**Independent review of Underground Mining at the Dolphin Mine on
King Island : Revision 1**

Prepared for: King Island Scheelite Project

March 2010

**A.D.Fudge
Polberro Consulting
PO Box 130, Wynyard,
TAS, 7325**

Figure 2: Estimate (MRO) incorporating post pillar and skin pillar resources in filled stopes

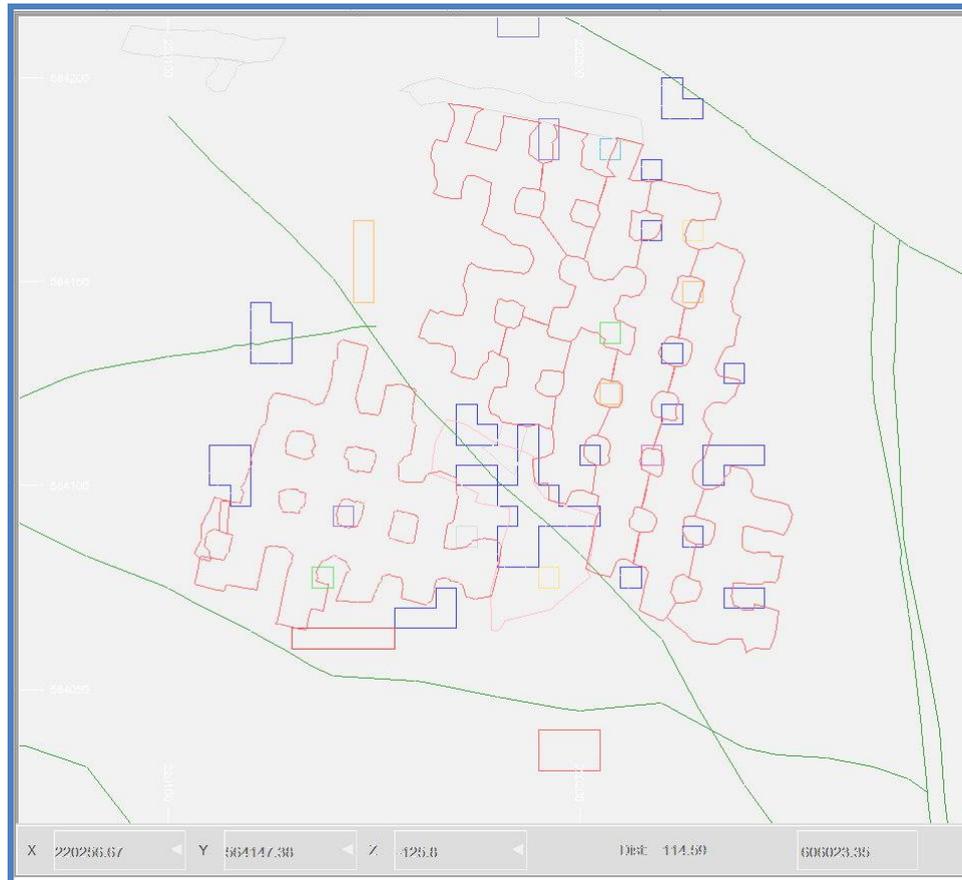
- Estimates 2 & 3 incorporate post pillar and skin pillar resource in/or adjacent to filled stopes which can not be recovered by an underground mining operation (see Figure 2). Estimates 2 & 3 also includes satellite ore pods and small ore cells that are unlikely to be economic to extract. (See Appendix 3 – Isometric Plot of AMC109034 mining inventory)

- Estimate 4 was produced by delineating areas that have a realistic prospect of recovery based upon the author's operating experience at the Dolphin Mine and is therefore significantly different to the global scoping approach used in Estimates 2 and 3. Some high grade sections of the Lower Wedge orebody – in particular – were excluded because of extremely poor ground conditions.

Figure 5: Sidewall failure (on occluded structure) in South Decline

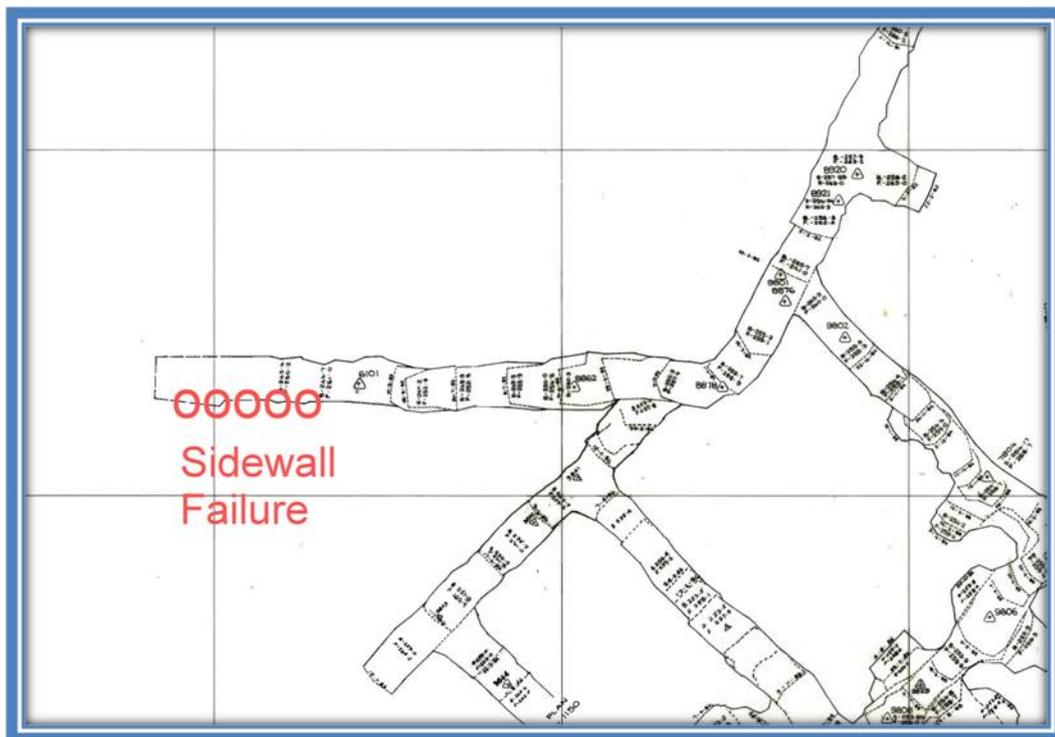
A main decline by-pass was planned (Southern Decline) and started from both ends several years before the mine closed to replace the section that eventually failed at -255m RL. The lower section of this by pass suffered a major sidewall failure during development and was abandoned.

The probable cause of the failure was an unexpected intersection with the Swan Fault - some metres north of its anticipated position which was intersected just before the decline was due to enter granite.

Figure 6: Benching Option when approaching levels above

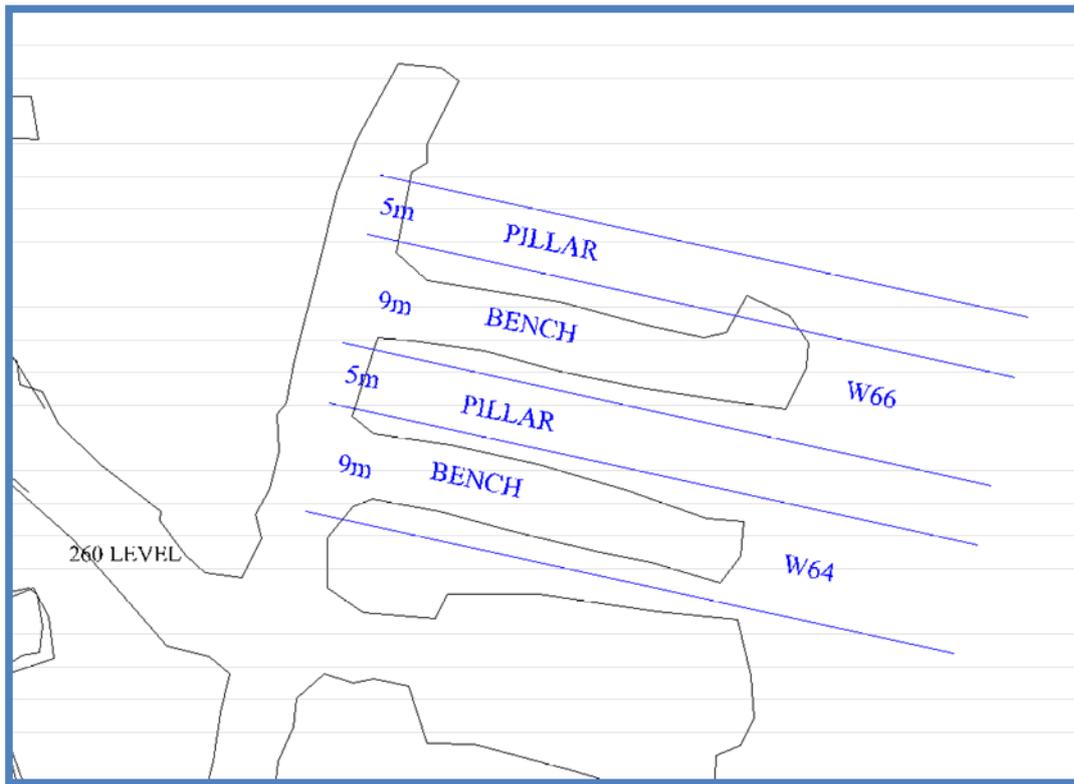
Lower Wedge 260 stope – The Lower Wedge 260 stope consists of the current active post pillar stope lift (2) above -255m level, the 240m Lower Wedge level development and 240 floor ramp. This stope will need to be mined as a post pillar until the resulting backs come within 10m (minimum) of any open or filled stoping

level above. If the upper development is open then the remaining ore between the levels may be mined as simple down hole vertical benches 9m wide (with 5m rib pillars) running transverse to strike along the original stope crosscuts such that each bench can be mined and filled individually. If the development above is filled as will be the case when the Lower Wedge 220m Level is approached then a retreat uphole bench may be mined, and preferably back filled, under a 2-3m back crown pillar. The uphole benching directly beneath Lower Wedge 220 level should be conducted only when the Lower Wedge 220 stope is completed.
